Docket Item #6
BAR CASE #2006-0128

ISSUE: Rear addition and alterations

APPLICANT: James Bognet and Carole Soloman by Linda Serabian

LOCATION: 509 Cameron Street

Figure 1 -
Proposed north
elevation

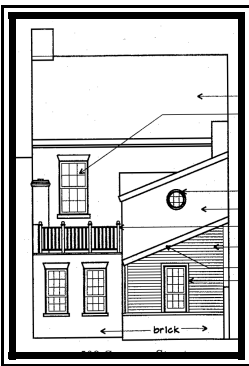
BOARD ACTION, OCTOBER 4, 2006: The Board combined the discussion of docket item #'s 6 & 7. On a motion by Mr. Smeallie, seconded by Mr. Wheeler, the Board voted to defer the application for restudy and encouraged the applicant's architect to consider eliminating the proposed roof deck and the location of the addition. The vote was 6-0.

REASON: The Board was concerned about the location and orientation of the proposed addition and roof top deck on the addition.

that the propose addition would significantly alter the existing house. In addition, the Board requested an elevation drawing showing the east elevation of the proposed addition.

Staff is supportive of the proposal for a number of reasons. First, it responds to suggestions concerning the parti recommended by the Board at the September 6th public hearing. Second, the massing of the rear addition is similar to a number of other additions approved by the Board at the rear of early 19th century houses with existing ells. Third, the rear of the house is only minimally visible across the public surface parking lot from North St. Asaph Street and the public perception of the house from the street remains unchanged. And fourth, the Board approved a rear addition to the early 19th century rear flounder at the residence adjacent to the west at 511 Cameron Street earlier this year (BAR Case #2006-0012, 2/15/06) which clearly changed the historic configuration creating, in the view of staff, the precedent for a similar type addition at this house.

1. Call Alexandria Archaeology immediately (703-838-4399) if any buried structural remains (wall foundations, wells, privies, cisterns, etc.) or concentrations of artifacts are discovered during development. Work must cease in the area of the discovery until a City archaeologist comes to the site and records the finds;
2. The applicant must not allow metal detection to be conducted on the property, unless authorized by Alexandria Archaeology; and.
3. The above statements must appear in the General Notes of all site plans and on all site plan sheets that involve demolition or ground disturbance (including sheeting and shoring and grading) so that on-site contractors are aware of the requirements; and,
4. Retention of the existing fenestration on the east wall of the second level of the existing ell.

Figure 3 - Proposed west elevation

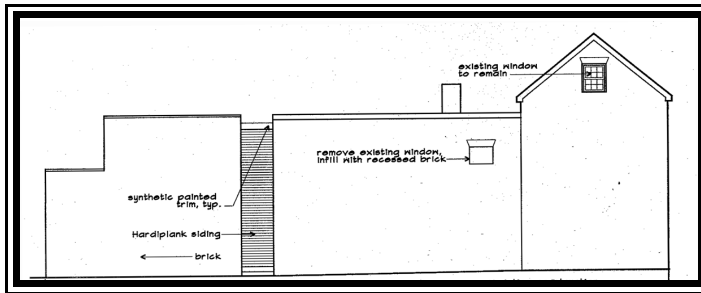
Staff has no objection to the alteration of the rear brick wall to accommodate a parking pad in the rear yard.
